Historic District Commission MEETING AGENDA

Monday, April 24, 2023 - 6:00 PM
Council Chambers, Easton Town Office
14 S Harrison Street

Proposed Project Plan
 $\frac{3}{8}" = 1'$

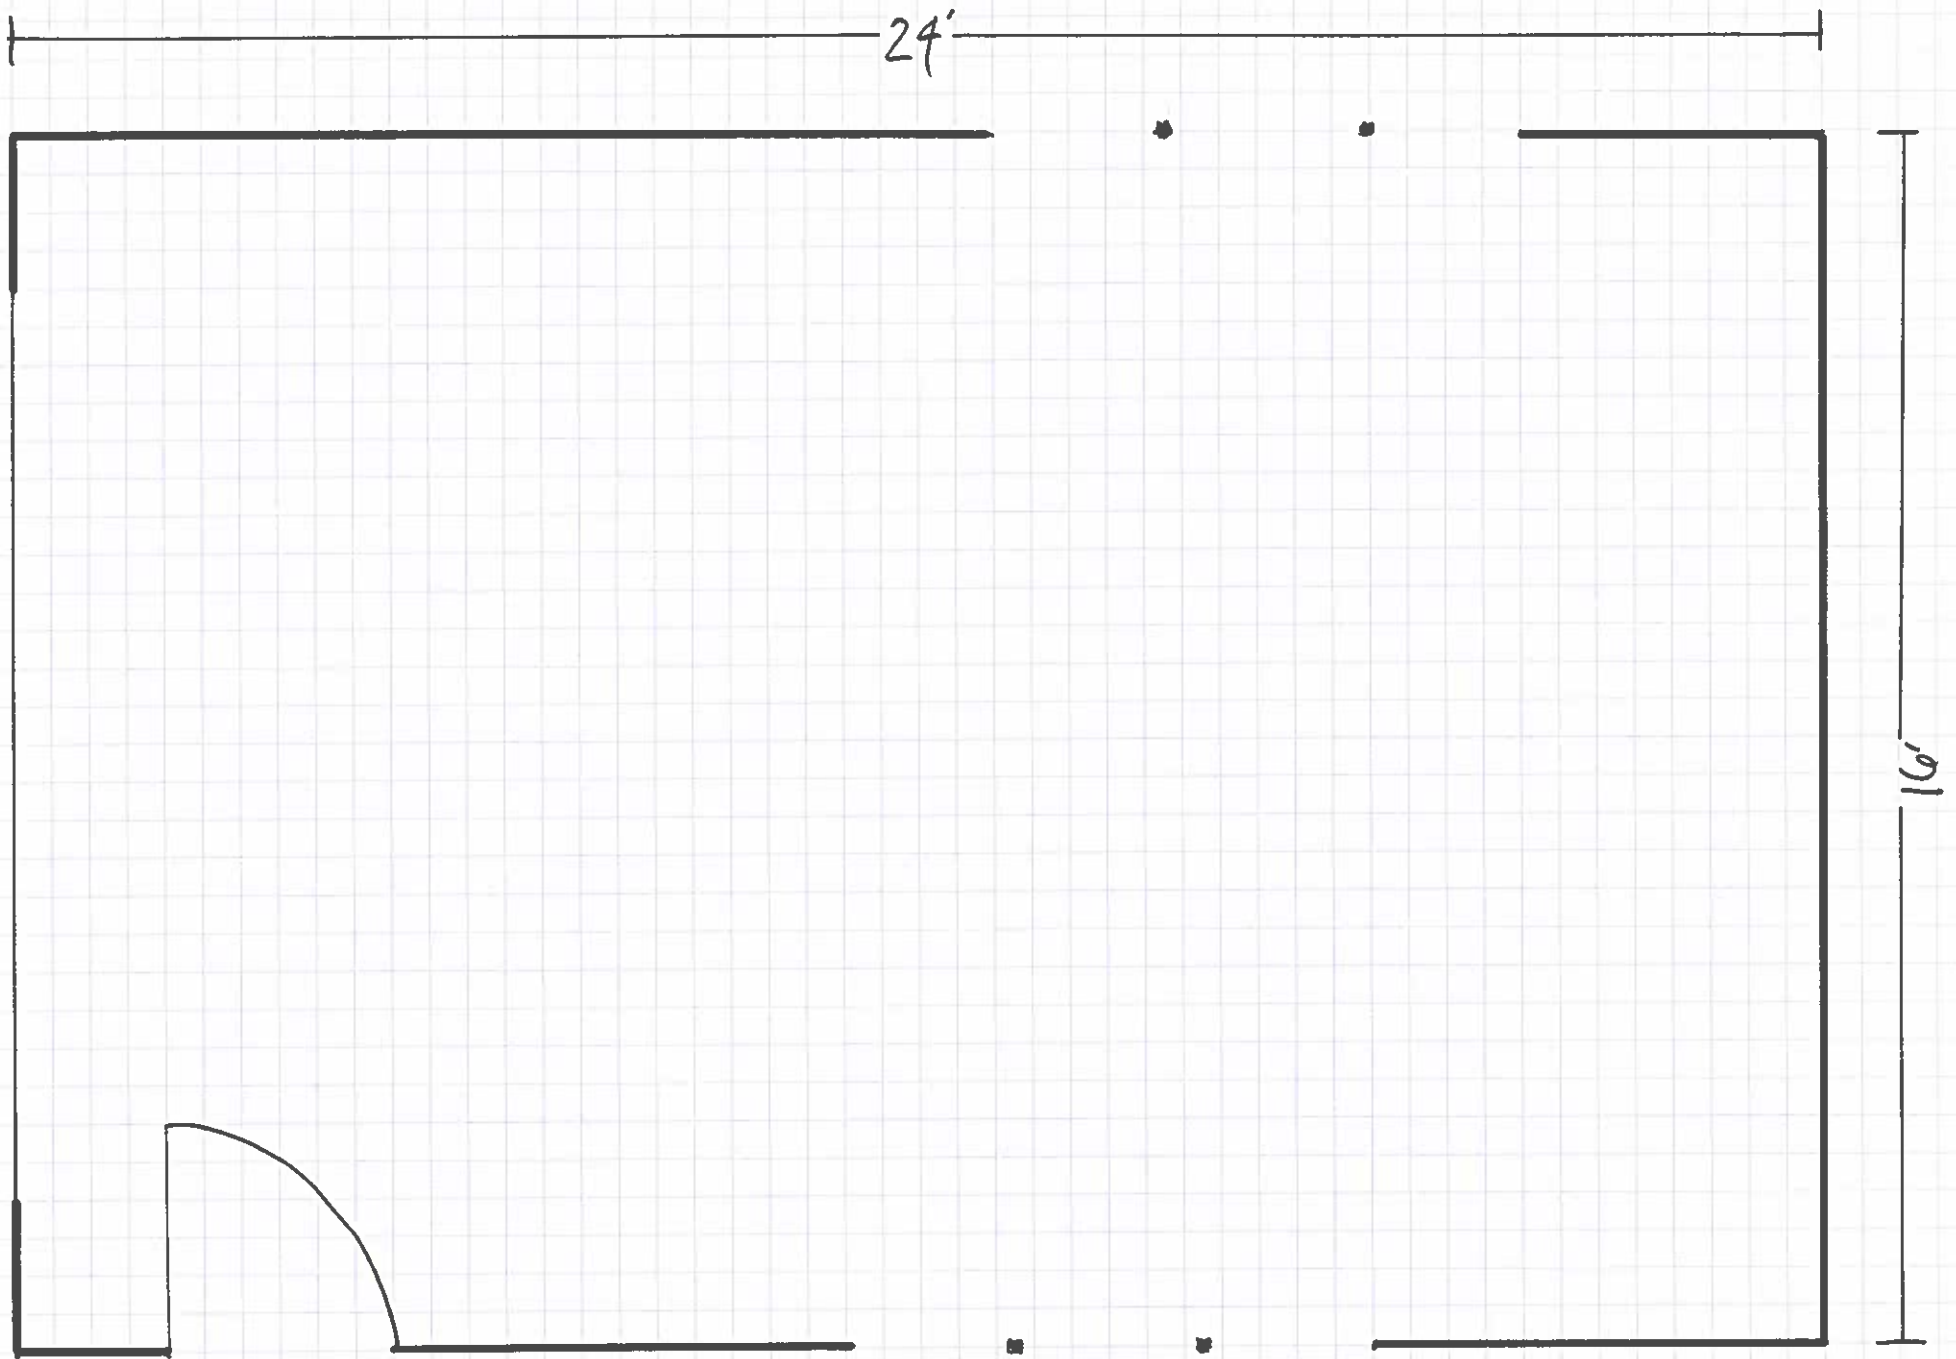
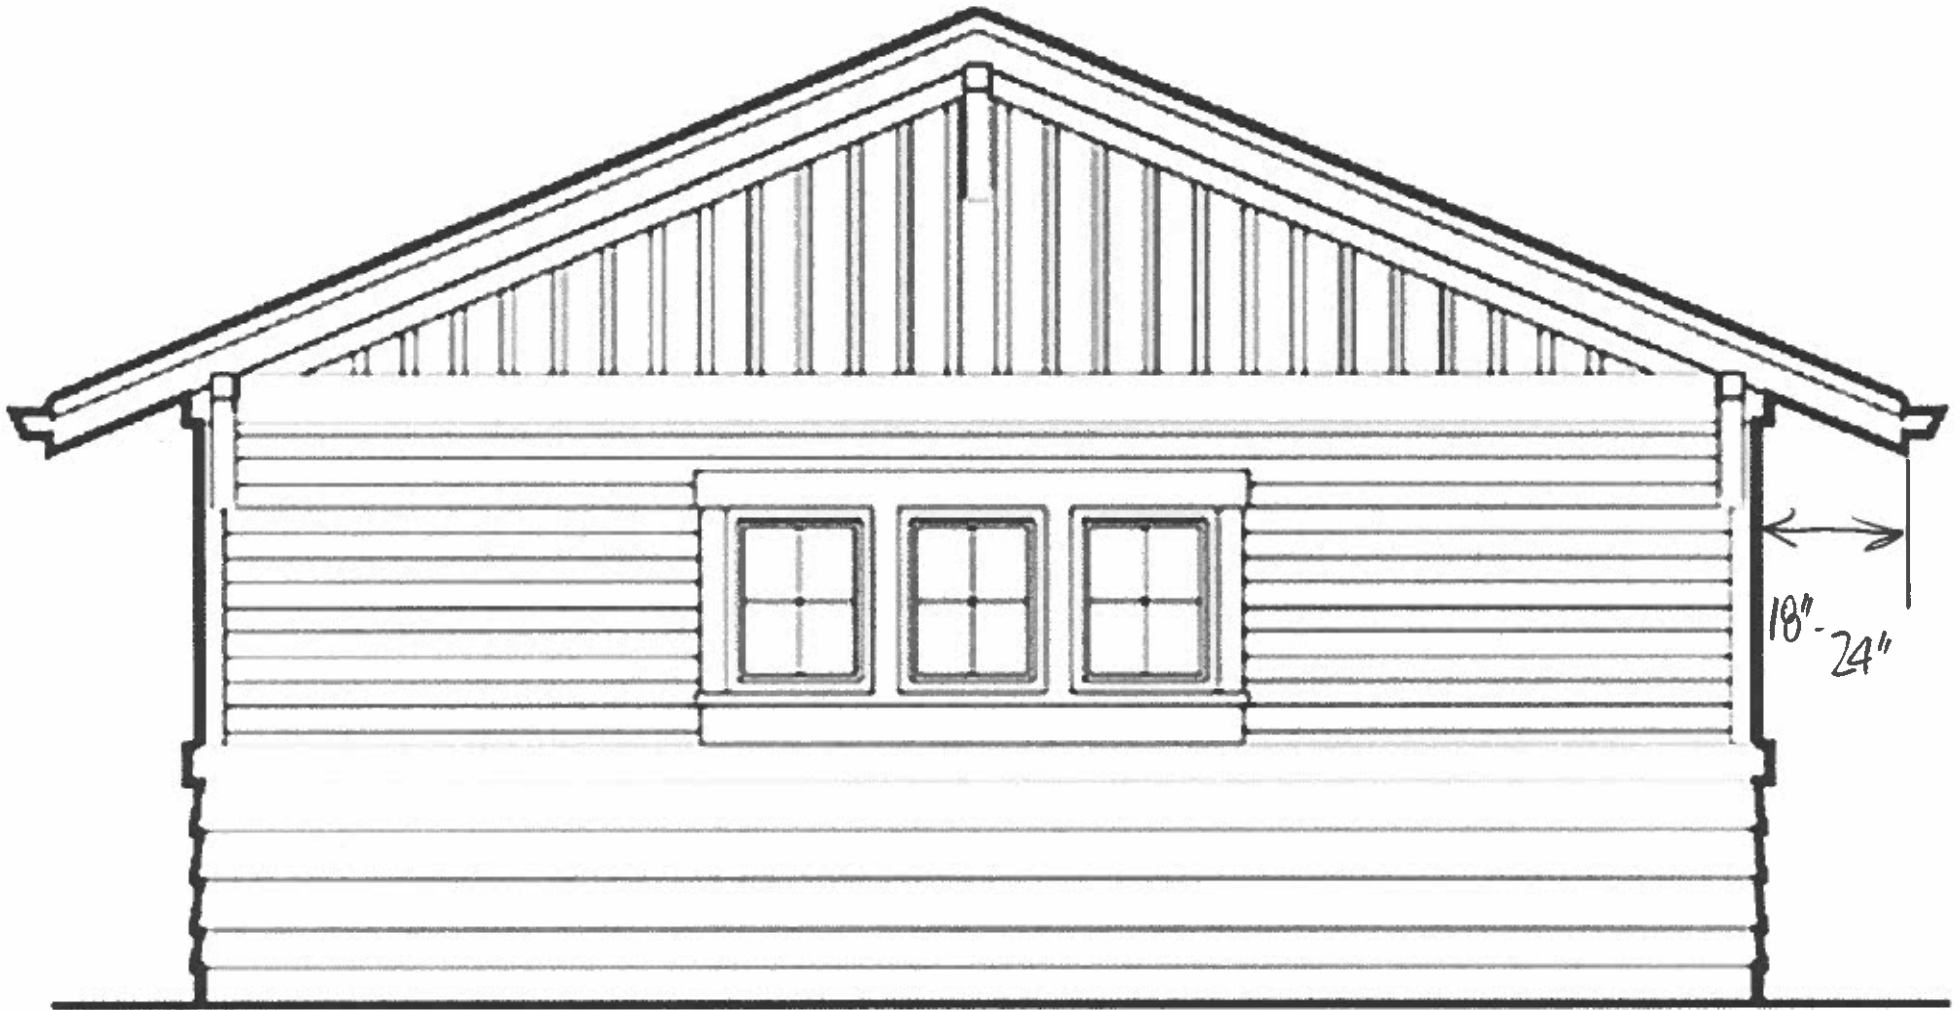
The applicant has now revised the scope of work to eliminate the proposed addition. The garage door will no longer be replaced and no windows will be added to the north elevation. Finally, the two windows flanking the entry door will be fiberglass-clad instead of the originally approved wood.
